Executive Director's Recommendation

Commission Meeting: February 7, 2013

Site Improvements and Perimeter Security
Herbert C. Hoover Building, United States
Department of Commerce
1401 Constitution Avenue, NW
Washington, DC

Approval of comments on revised
concept design

Figure 12: Revised Concept Site Plan Detail - 15th Street, NW

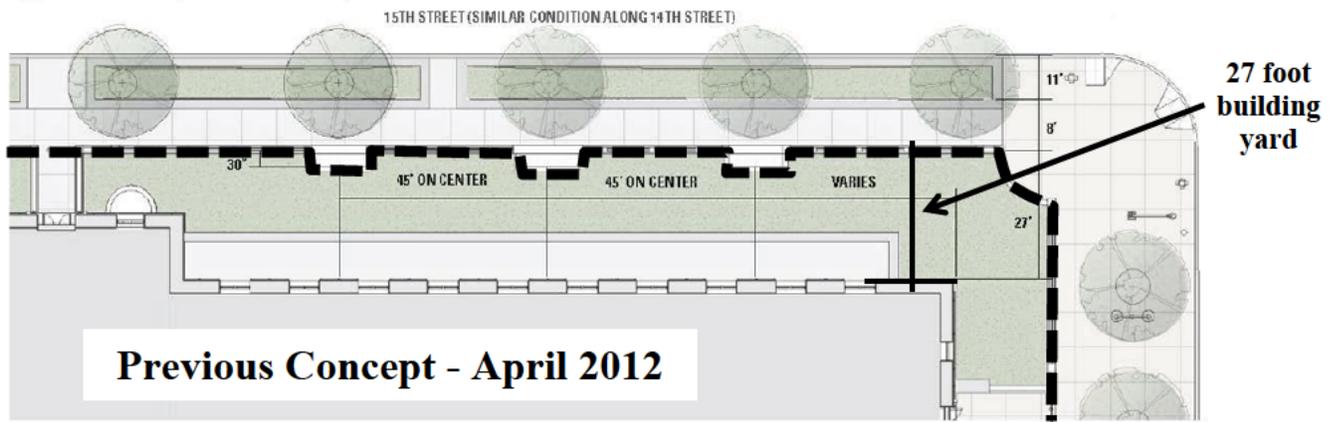
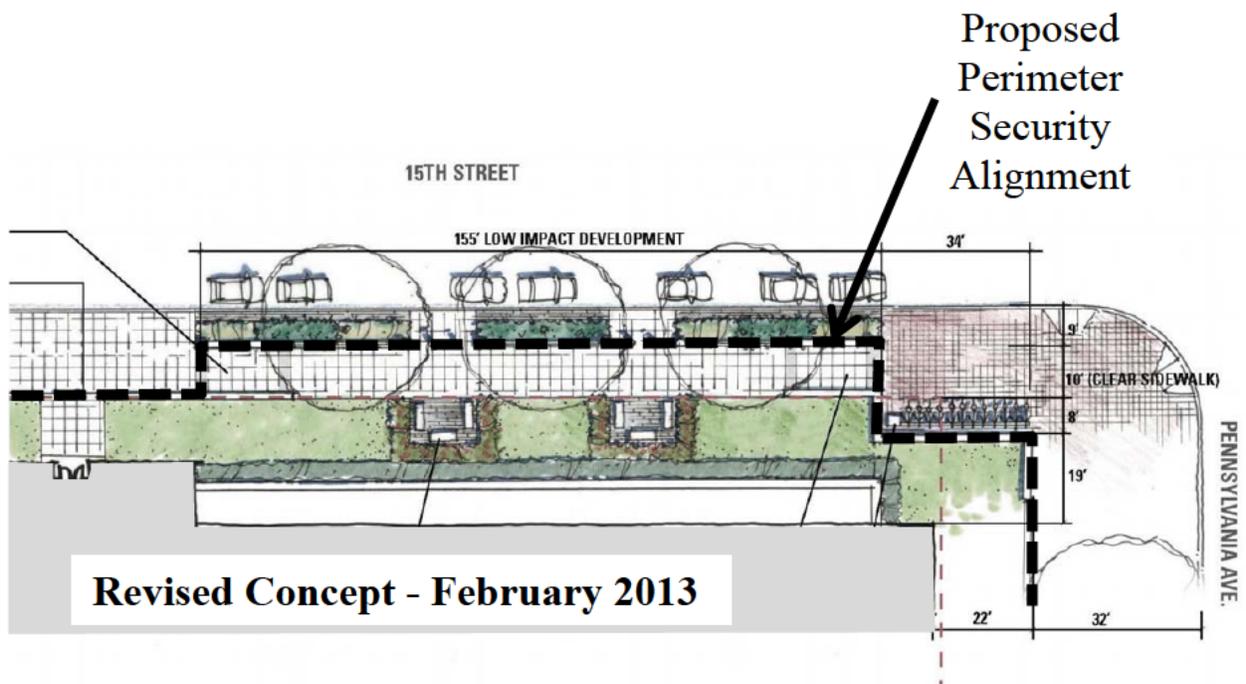
Notes that the proposed perimeter security elements that are in public space along 14th Street and 15th Street, NW are not consistent with this policy

As noted earlier, the areas where the perimeter security will be located in public space are along the northern and southern ends of the sidewalks for both 14th and 15th Streets, NW. The building

yard extends at least 24 feet from the Hoover Building - 27 feet along 15th Street and 24 feet along 14th Street. Under NCPC policy, this requires the security elements to be located at or within the building yard. Figure 11 illustrates the previous concept design from April 2012. The other two images, Figures 12 and 13, are site plan details showing the new alignment of the perimeter security along 14th and 15th Streets, NW.

This proposal is not compliant with another NCPC policy stating that perimeter security elements in public space should be discouraged and minimized. GSA's revised concept design indicates that approximately 750 linear feet, or 34 percent, of the proposed perimeter security along 14th Street and 15th Street will be in public space. As these security barriers are located in public space, NCPC policy states that they should be integrated into the landscape and their visual and physical impact should be minimized. Staff would recommend that GSA coordinate with District of Columbia Department of Transportation and others to minimize the impact of these on public space.

Agrees to consider a partial exception to this policy for the perimeter security elements located in public space, on the condition that the applicant is able to demonstrate, in future submissions, that the public benefits provided outweigh the impact of the security elements in public space by:

Figure 13: Revised Concept Site Plan Detail - Corner of 14th Street, NW and Constitution Avenue

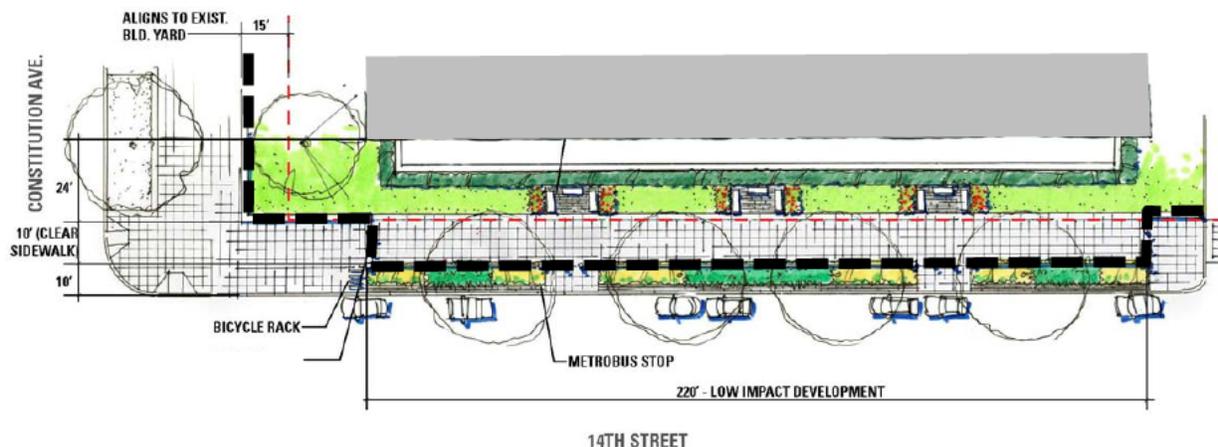
Also, along Constitution Avenue, the established planting areas on either side of the existing pedestrian entrances to the Hoover Building will be extended into public space, in the south wall, as part of the National Aquarium Entrance Pavilion project. The secure perimeter will be 38 feet from the building. The public space will be 27 feet wide, which includes a 13 foot sidewalk and a 14 foot tree planting area. Allowing the perimeter security element to be located in the back wall, or north wall, of the entrance pavilion would ensure that this project is in conformance with the policy.

Figure 14: White House Visitor's Center Entrance, Pennsylvania Avenue – Site Plan

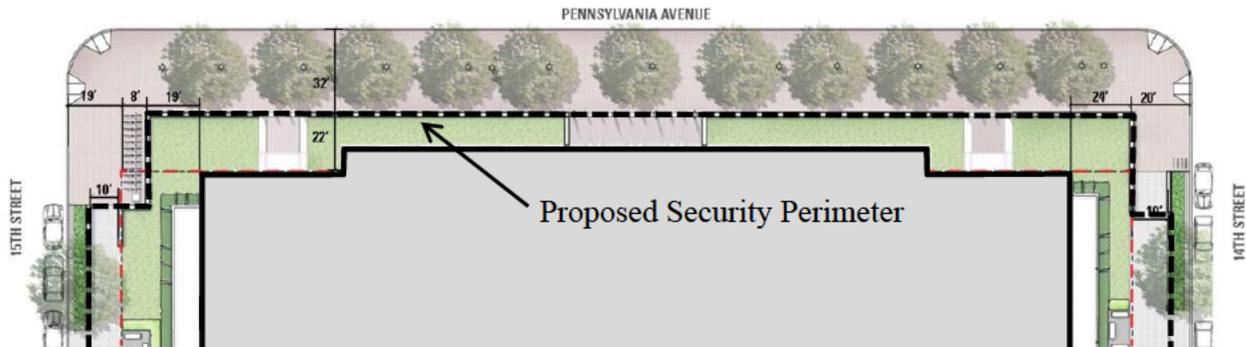
Approximately two-thirds of the perimeter security included in the revised design is consistent with the policies in the UDSP. For example, along Pennsylvania Avenue at the WHVC main entrance, the building façade is either at the property line or over it - a portion of the building is actually located in public space. GSA is proposing that the secure perimeter be located in public space. However, as the building yard is less than 20 feet, and the existing building yard line will be maintained this portion of the project is consistent with the UDSP policies.
